## SERVICE INSTRUCTION

# Introduction of a radiator retrofit kit part no. 881535 for the new radiator part no. 997083 on ROTAX® Engine Type 912 i, 912 and 914 (Series)

ATA System: 75-00-00 Cooling system

Fig. 1  
Radiator retrofit kit

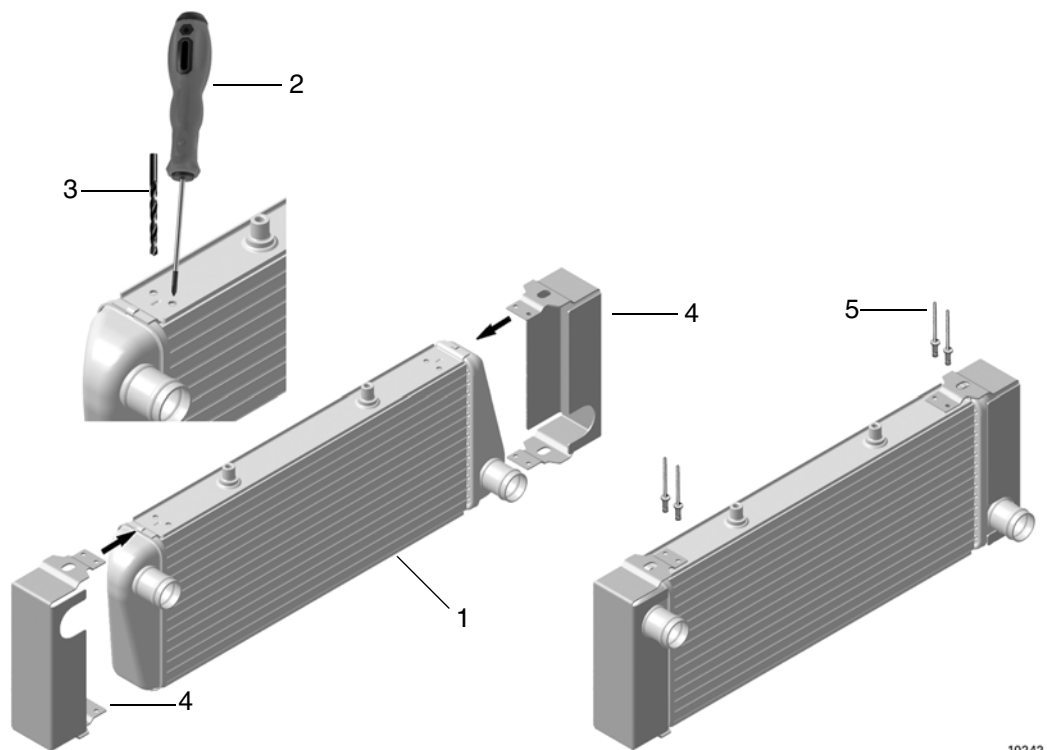
In the course of continuous development, a new radiator (part no. 997083) has been introduced. Because the radiator has a changed outside contour and dimension changes, a radiator retrofit kit, (part no. 881535) has been created, which should be used in installation situations where a rectangular mounting is needed. For this purpose, corresponding cover plates have to be riveted onto the radiator.

Step	Procedure
1	Enlarge the holes of the radiator (1), using a suitable screw driver (2). Tilt the fins slightly to the side.
2	If necessary use a metal drill $\varnothing 4.1$ mm (3) to rebore the holes of the radiator and the cover plates (4).
3	Install the cover plates and observe the correct mounting position.
4	During the riveting process apply some force to the rivets (5), so that they are pushed into the holes. Reposition the riveting tongs accordingly.
